# SERVICE LETTER

No. 138

TO: All Owners of PA-20 Airplanes up to Serial No. 20-115

SUBJECT: Rudder Pedal Tube Attachment

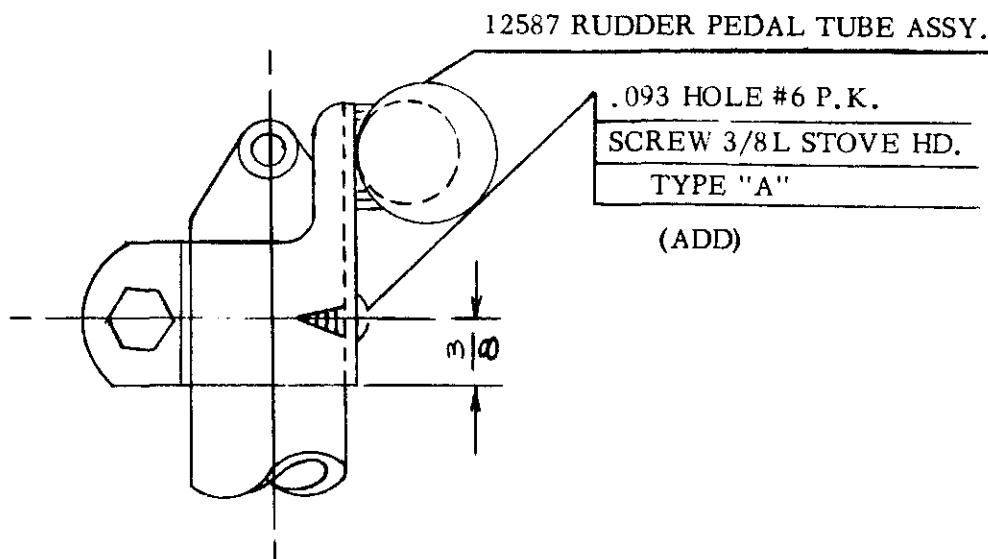
It is recommended that a #6 x 3/8" Parker Screw be installed in the rudder pedal tube clamp of the right hand rudder pedals to eliminate the possible rotation of the rudder pedal cross tube on the torque tube arm. The Parker screw should be installed, as per sketch shown below.
